OXY USA INC.

PURE GOLD D FEDERAL 005

30-015-27216

NOI TO PERMANENTLY ABANDON THIS WELL VIA CEMENT PLUGGING.

Proposed Wellbore
PURE GOLD D FEDERAL 005

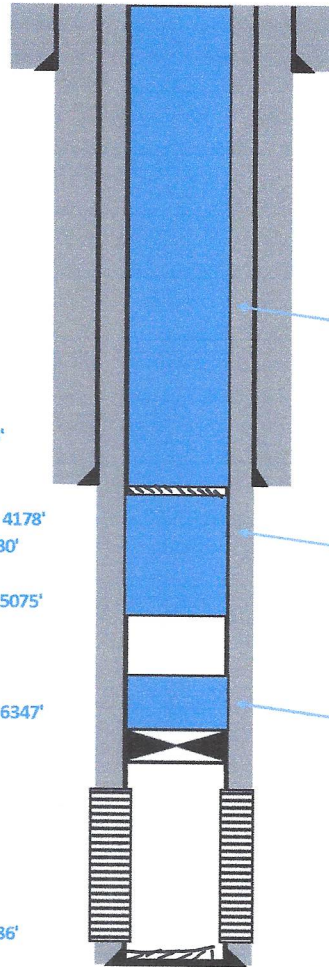
458 SX CMT FROM ~~4118'~~ TO SURFACE.
VERIFY CMT AT SURFACE

SPOT 108 SX CMT FROM 5125' TO 4153'
WOC AND TAG

SET CIBP @ ~~6407'~~ WITH TUBING. SPOT
25 SX CMT FROM ~~6407'~~ TO ~~6107'~~
WOC AND TAG 6604' to 6351'

TAG TD & Dump Bail cement from
8036' to 7942'. WOC & TAG. (14', 12 SXS class H)
